# 16 ALMA STREET

Design & Access Statement – 19/03/2013

## CASE OFFICER FEEDBACK

### Existing / Proposed Materiality

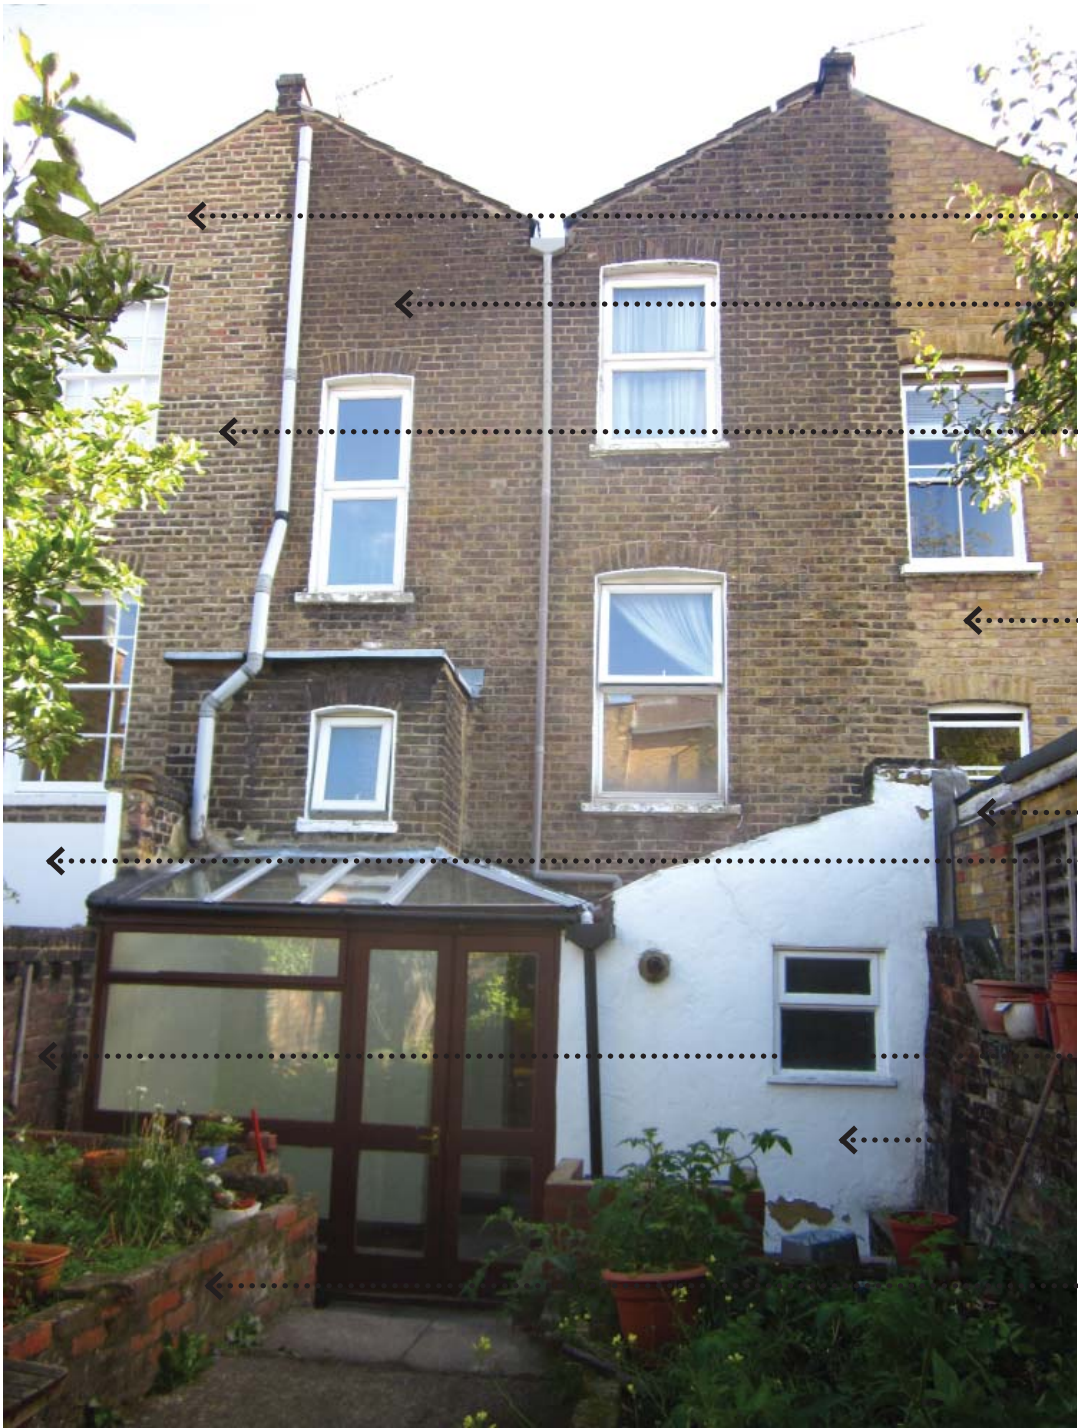
During the previous planning application process (2012/6325/P) and in the email included as an appendice to this Design and Access Statement the previous case officer offered feedback and was said that the proposal should be of matching brickwork.

The photograph opposite shows the current rear elevation at 16 Alma Street and it can be seen that matching brickwork in this case is no easy task. There are currently 4 different types of brick used on the rear elevation and attempting to match and add to this complicated jigsaw of brick would damage the architectural integrity of the rear elevation. An addition constructed to blend in to the existing setting would not respect the heritage of the site and would make it hard to distinguish between what is historic and what is new.

Our proposal, of grey cementitious toned tile , seeks to clearly read as a new addition that sits subtly and comfortably amongst this blend of brickwork. This scheme has been carefully designed by award winning architects Coffey Architects to enhance the conservation area with a high quality new addition.
